UNITED STATES
NUCLEAR REGULATORY COMMISSION
WASHINGTON, D. C. 20555

Am-54 to
DPR-29

The Commission has issued the enclosed Amendment No. 54 to Facility Operating License No. DPR-29 for the Quad Cities Nuclear Power Station, Unit No. 1 and Amendment No. 45 to Provisional Operating License No. DPR-19 for the Dresden Nuclear Power Station, Unit No. 2. These amendments are in response to your letter dated December 4, 1979 as supplemented December 20, 1979.

AMENDMENT TO FACILITY OPERATING LICENSE

FIGURE 3.5-1
MAXIMUM AVERAGE PLANAR LINEAR HEAT GENERATION RATE (MAPLHGR) VS. PLANAR AVERAGE EXPOSURE
(Sheet 2 of 3)

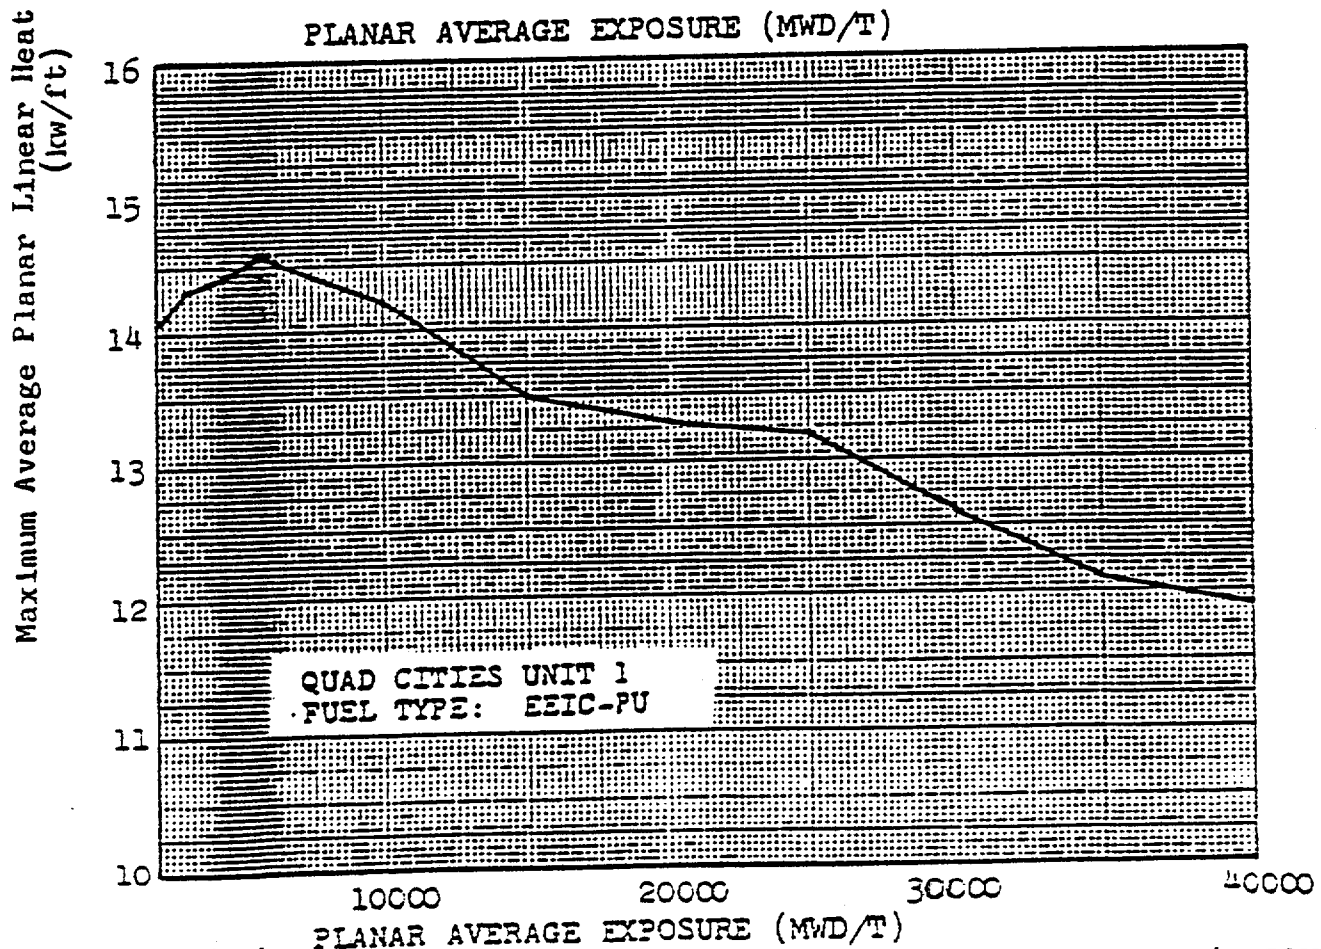
The amendments extend the MAPLHGR curves for improved 7x7 (7D230) and 7x7 mixed oxide fuel bundles to planar average exposure values of 40,000 MWD/t (short ton).
